## COBRA-SFS Model and Results for NUHOMS-32PT Spent Fuel Storage Canister

### Description of Transnuclear NUHOMS-32 PT ANSYS Model

### **Comparison of Transnuclear ANSYS model and COBRA-SFS Model of NUHOMS-32 PT**

Figure 5. Illustration of parallel path  $k_{eff-along 1}$  assumed in TN's ANSYS model for the XM-19 basket plate and assumed 0.0075" gas gap on either side

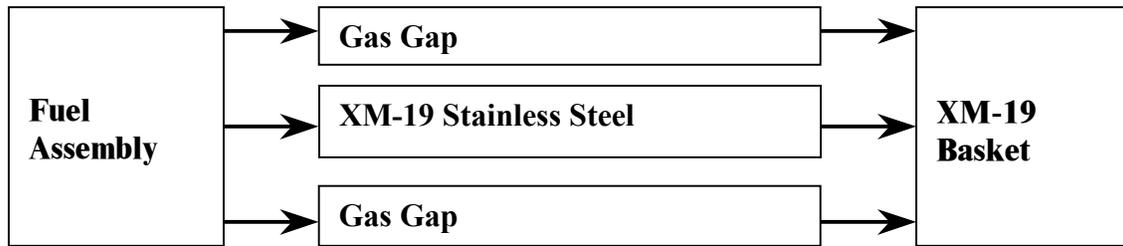
Figure 5 represents the heat transfer path as modeled in ANSYS by TN for heat flow from the fuel assemblies through the “gas gap+XM-19+gas gap” sandwich that only exists in select locations. After passing through this incorrectly assumed parallel path to an XM-19 node, heat transfer along the XM-19 material heading out radially to the canister wall is treated as simply conduction through the XM-19 material. Coincidentally, only one gas gap should have been assumed given TN’s selected modeling approach. Figure 6 represents the heat transfer path as modeled in ANSYS by TN for heat flow from the fuel assemblies through the L-shaped “aluminum+gas gap+Poison plate” sandwich that only exists in select locations. After passing through this incorrectly assumed parallel path, the heat flows into the XM-19 stainless basket material through another incorrectly assumed parallel path as depicted in Figure 5, then radially outward to the canister wall.

This approach can be used to represent only the heat flow paths along the layers of the plates and the path along the axial length of the canister. It is not an appropriate representation of the heat flow path along the continuous XM-19 stainless steel plates to the support rails,

which is the primary route of heat removal. Axial heat transfer, which can be represented with the effective thermal conductivity based on parallel-paths, is capable of removing only a small part of the heat from the canister. As such, bi-directional material property definitions are required in order to accurately specify the orthotropic nature of heat conduction through these components, given TN's geometric construction approach.

Figure 6. Illustration of parallel path  $k_{eff-along 2}$  assumed in TN's ANSYS model for the L-shaped aluminum and neutron poison plates and the associated 0.00375" gas gap

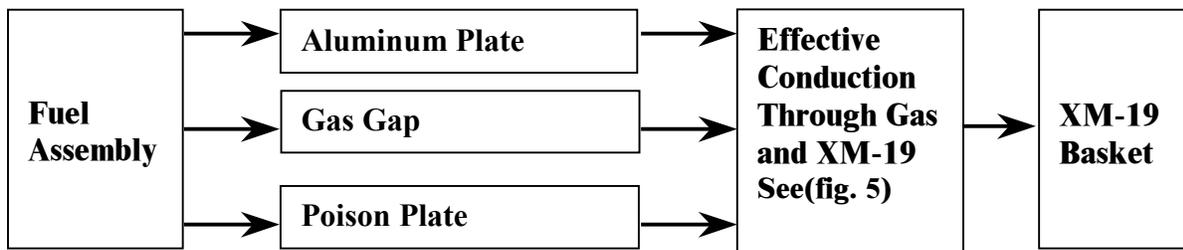
Making an example of the path featured in Figure 6, for the direction passing through the right or lower wall of the “cell” depicted in Figure 7, the applied effective thermal conductivity ( $k_{eff\text{-}along\ 2}$ ), for the Al/neutron poison materials sandwiching the assumed 0.00375” gas gap (excluding the XM-19 and surrounding gap gas), works out to be around thirty times that which should have been applied ( $k_{eff\text{-}through\ 2}$ ), as illustrated by the following calculations.

Values of  $k_{eff\text{-}along\ 1}$  and  $k_{eff\text{-}along\ 2}$  were applied in all directions in the ANSYS model supplied by TN, to define the effective thermal conductivity in the bodies representing 1) the basket material region and 2) the Al/neutron poison plate region. These material regions were not modeled in ANSYS with separate material orientation (orthotropic) and property definitions. Hence, the same values of  $k_{eff\text{-}along\ 1}$  and  $k_{eff\text{-}along\ 2}$  were applied in both the “along” and “through” directions.

Figure 7. Conceptual diagram of radial heat flow through the basket region

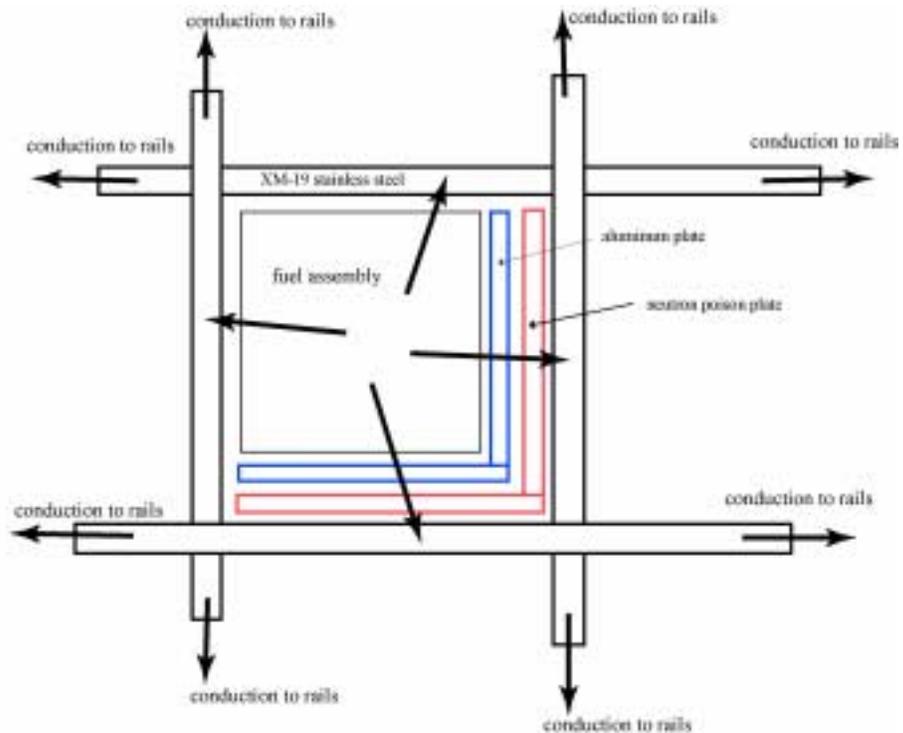
Shown in Figure 7 is a conceptual representation of these "radial" heat transfer paths through the basket. In no case can the heat flow be treated as following a parallel path (along the layers) exclusively, as described by Eq. (1) above. The effect of using a  $k_{eff-along}$  defined as in Eq. (1) for heat transfer "through" the basket cell edges, gaps and ancillary components results in a significant overestimation of the effective thermal conductivity of the basket structure. Using the path featured in Figure 5 as an example, in this case for the direction passing through the left or upper wall of the "cell" depicted in Figure 3 involving helium, the applied effective thermal conductivity ( $k_{eff-along 1}$ ) works out to be a little more than four times that which should have been applied ( $k_{eff-through 1}$ ) as illustrated by the following calculations.

Inserting appropriate values for these thermal conductivities and using the specified dimensions of the various components yields a value for  $k_{eff\text{-}along\ 1}$  that works out to be approximately 4.3 to 4.7 times larger than  $k_{eff\text{-}through\ 1}$ .

It could be argued that this lumping of material properties is an appropriate representation for heat transfer through the basket material in the *axial* direction (from canister end to end), but it is obviously not correct in the radial direction involving “through” heat paths. Heat transfer must pass serially through the aluminum and neutron plates and associated gas gaps and then into and through the XM-19 stainless steel basket structure to travel out to the support rails.

Figure 8.  
Figure 9.

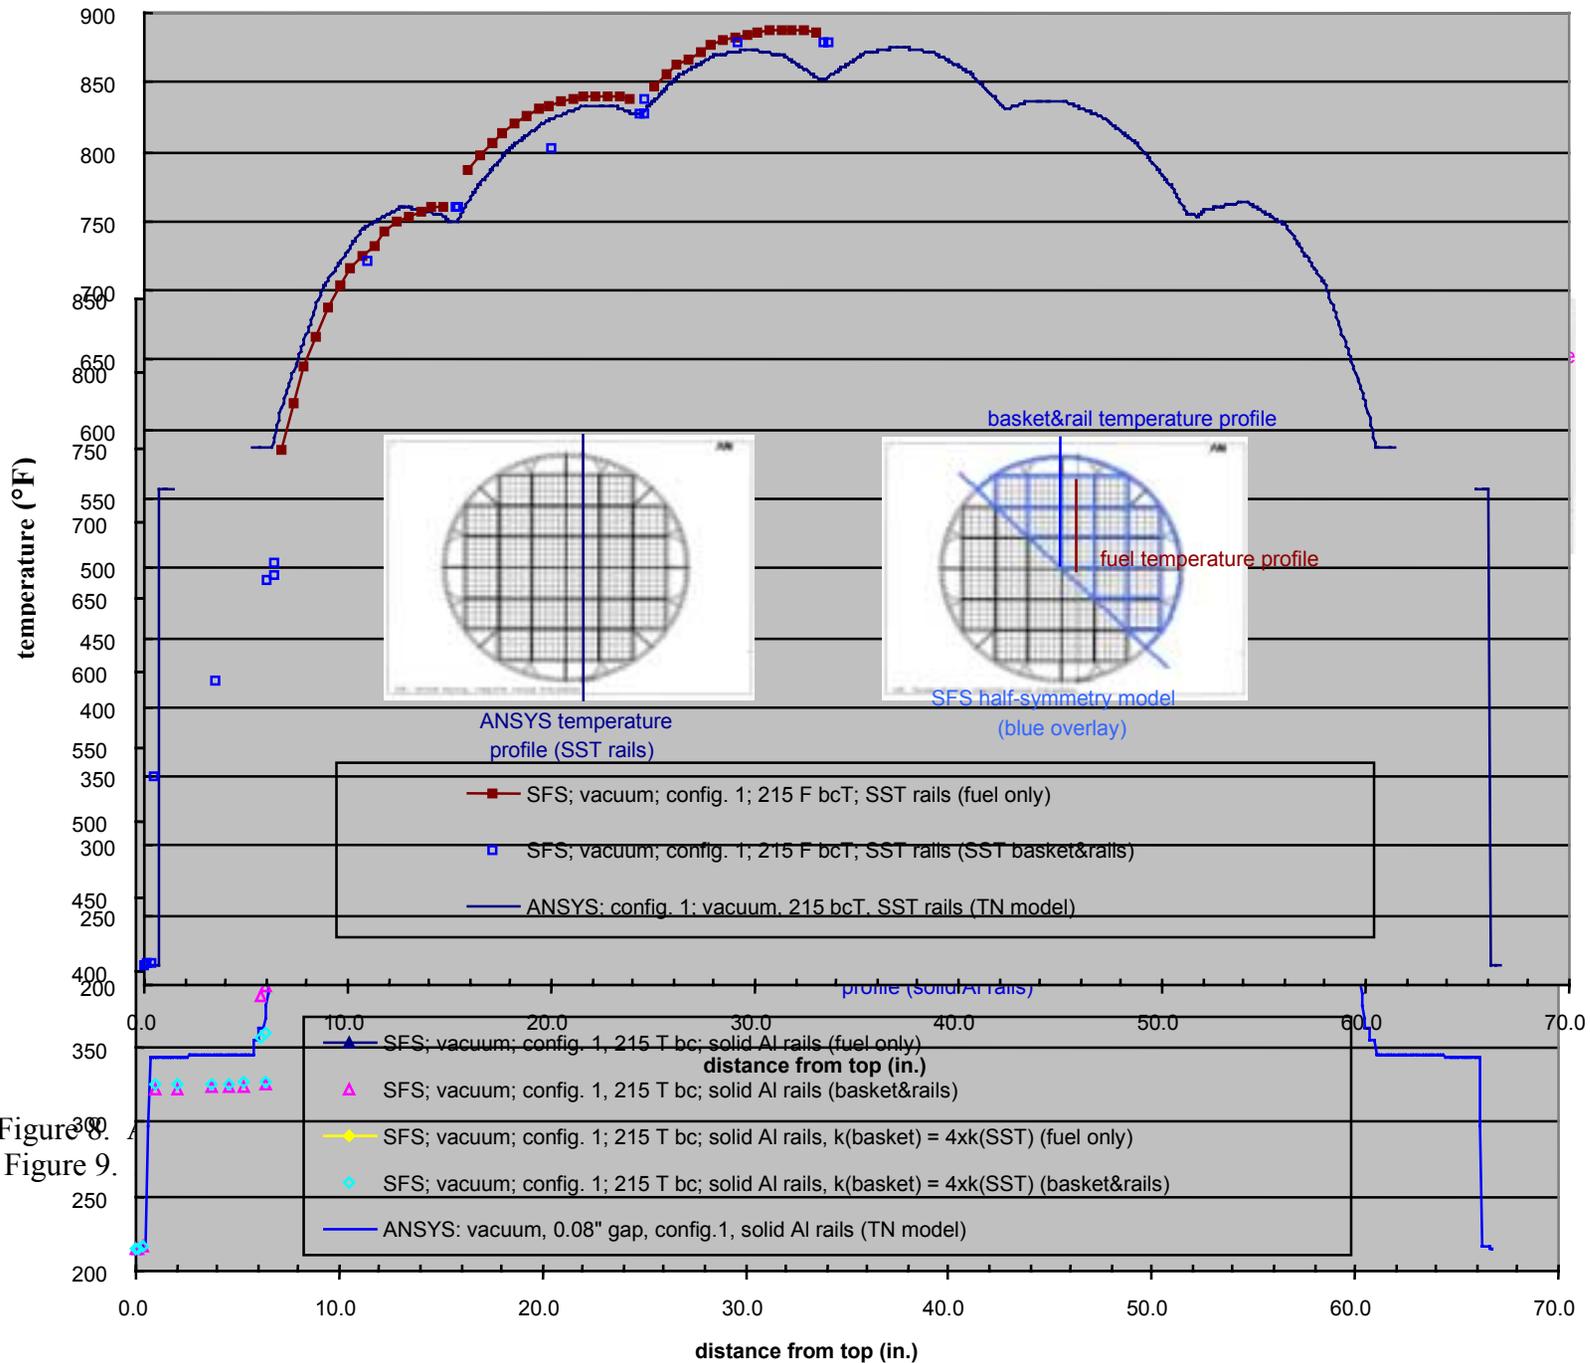
The profiles in Figure 8 show that the ANSYS and COBRA-SFS models predict essentially the same thermal behavior in the fuel assemblies when the canister is in vacuum. Figure 8 also shows that the temperatures predicted with the ANSYS model in the stainless steel rails are significantly different from the COBRA-SFS results. In the ANSYS profile, the temperature difference between the inner plate of the rail and the outer curved plate of the rail is unrealistically small for the physical conditions (only about 30 °F). The temperature difference between the outer rail plate and the inner surface of the canister shell is unreasonably large (approximately 340 °F over a distance of 0.08"). By contrast, the COBRA-SFS results predict a temperature drop of approximately 145 °F across the structure of the stainless steel rails, and a temperature drop of only about 135 °F across the assumed gap between the outer edge of the rails and the canister shell.

The temperature profile in the rail region predicted with the ANSYS model results from the inappropriate superposition of heat conduction through the stainless steel structure of the rails and the aluminum plates fastened to the inner surfaces of the steel plates forming the rails. In the ANSYS model, these conductivities are treated as parallel heat transfer paths through the structure of the rails, when in fact there is no parallel path from the basket to the outer edge of the rail through the aluminum plates. The only available continuous conduction path is through the stainless steel. The only heat transfer benefit that can be conferred by the aluminum plates is to enhance radiative heat transfer across the open lattice of the rail structure. However, this

The profiles in Figure 9, comparing the ANSYS and COBRA-SFS results for vacuum conditions with the solid aluminum rails, further illustrate this problem. When the appropriate thermal conductivities are used in the basket and rail regions, as shown by the COBRA-SFS results, the peak clad temperature is 801 °F, more than 112 °F above the value of 713 °F predicted with the ANSYS model. COBRA-SFS results obtained with the thermal conductivity of the basket artificially enhanced to about four times that of stainless steel lower the predicted peak clad temperature to about 647 °F; approximately 155 °F lower than the peak temperature predicted for the same design with the thermal conductivity of the solid nodes of the basket modeled correctly. This result is lower than the ANSYS results by about 65 °F, mainly because the COBRA-SFS model does not include most of the conservative assumptions incorporated in the ANSYS model. (In general, COBRA-SFS is applied using 'best estimate' modeling assumptions, and will usually predict temperatures somewhat lower than conservative licensing calculations.) In this case, these results show how sensitive the peak clad temperature is to thermal properties of the basket material. When the canister is in vacuum, the dominant mode of heat transfer from the fuel to the basket is radiation, and heat moves through the basket to the rails almost exclusively by conduction through the stainless steel plates of the basket.

Figure 10.  
Figure 11

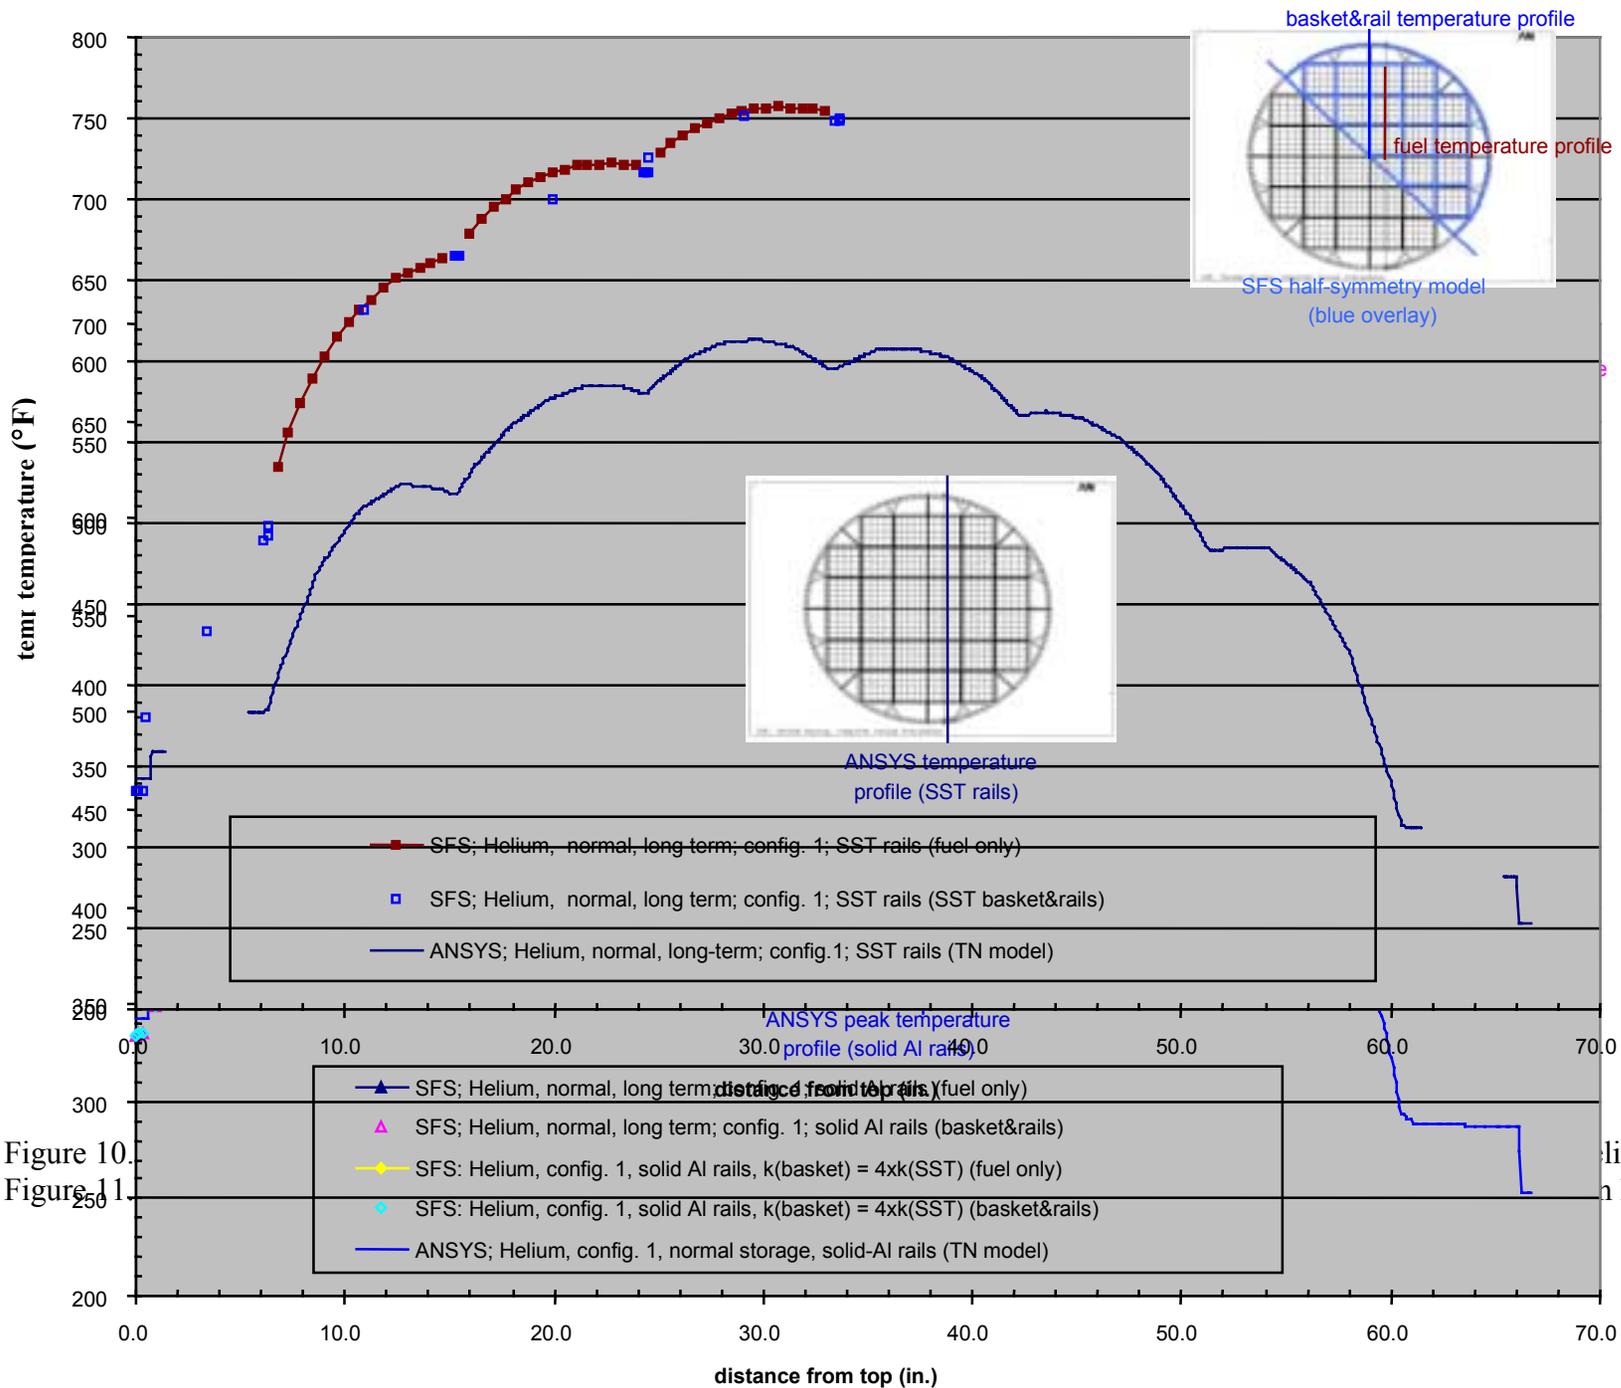
The profiles in Figures 10 and 11 show comparisons of ANSYS and COBRA-SFS predictions of temperature profiles for both the stainless steel and solid aluminum rail designs with helium as the fill medium rather than vacuum. These profiles show essentially the same thermal behavior and temperature trends as were noted for the vacuum case. The only significant difference is that the peak temperatures are somewhat lower, due to the relatively high thermal conductivity of helium in comparison to the thermal conductivity of the extremely attenuated air in the vacuum case.

Another discrepancy noted in the TN ANSYS model was the large difference in the peak clad temperatures predicted for the helium and vacuum cases for the stainless steel rail design. In the ANSYS calculations, the peak clad temperature for the vacuum case is 875 °F, and for the helium case it is only 613 °F; a difference of about 262 °F, in contrast to the difference of approximately 130 °F obtained in the COBRA-SFS calculations. This result is contrary to experimental data obtained in instrumented spent fuel canisters for a wide range of decay heat loads, geometric designs, and storage orientations, with backfill media that included air, helium, and vacuum storage. The increased effective thermal conductivity in the basket region (and in the rails, for the stainless steel rail design) results in a significant under prediction of the peak clad temperature in the ANSYS calculations. The results obtained in the TN ANSYS model do not appear to agree with published data.
